Access Compliance Report

Public Rights-of-Way

Intersection ID: 52929	Main Street: ENGLISH_OAK_LEAF_CT	Cross Street: GRAY_OAK_LN	Location:	N
ADA ID: CC4D2BA71CA4	Ramp Type: Perp	Initial Pass/Fail: Fail	Overall Compliance: No	Severity Score: 21.25
Codes/Mitigation Info/Possible Solution		Field Measurements/Component Compliance

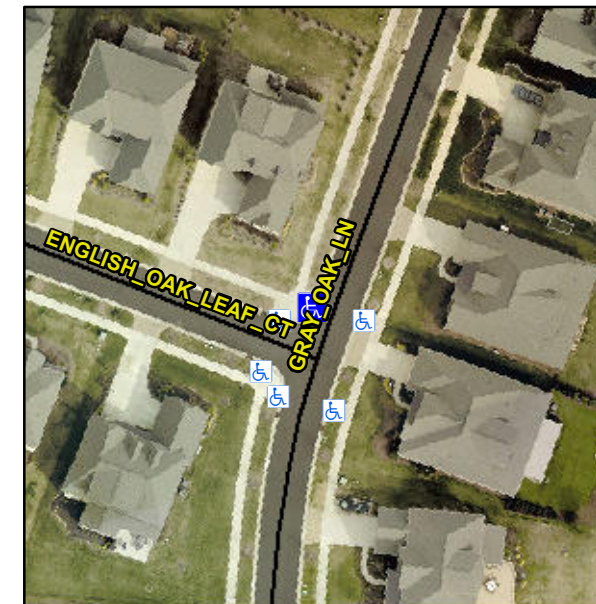
R304.5.1, R304.2.2

Compliance	Description	Data	Compliance	Description	Data
N/A	Ramp Length (in)	78.0	No	Ramp Slope (%)	8.4
No	Ramp Width (in)	46.0	Yes	Ramp XSlope (%)	1.5
N/A	Flare Type LT	N/A	N/A	Flare Type RT	N/A
N/A	Flare Slope LT (%)	N/A	N/A	Flare Slope RT (%)	N/A
N/A	Flare Traversable LT?	N/A	N/A	Flare Traversable RT?	N/A
N/A	Landing Length (in)	N/A	N/A	DWS Provided?	N/A
N/A	Landing Width (in)	N/A	N/A	DWS Contrast?	N/A
N/A	Landing Slope (%)	N/A	N/A	DWS Length (in)	N/A
N/A	Landing X Slope (%)	N/A	N/A	DWS Full Width?	N/A
N/A	Landing Curb? (Y/N)	N/A	N/A	DWS Offset (in)	N/A
N/A	Shared Landing?	N/A			
N/A	Gutter Ponding?	N/A	N/A	Gutter Slope (%)	N/A
N/A	Gutter Lip Ht (in)	N/A	N/A	Gutter X Slope (%)	N/A
N/A	Painted X Walk1?	No	N/A	Painted X Walk2?	N/A
	X Walk 1 Direction	To SE		X Walk 2 Direction	N/A
N/A	X Walk 1 Width (in)	N/A	N/A	X Walk 2 Width (in)	N/A
	X Walk 1 Slope (%)	2.8		X Walk 2 Slope (%)	N/A
	X Walk 1 X Slope (%)	1.6		X Walk 2 X Slope (%)	N/A

Remove & Replace Entire Ramp.
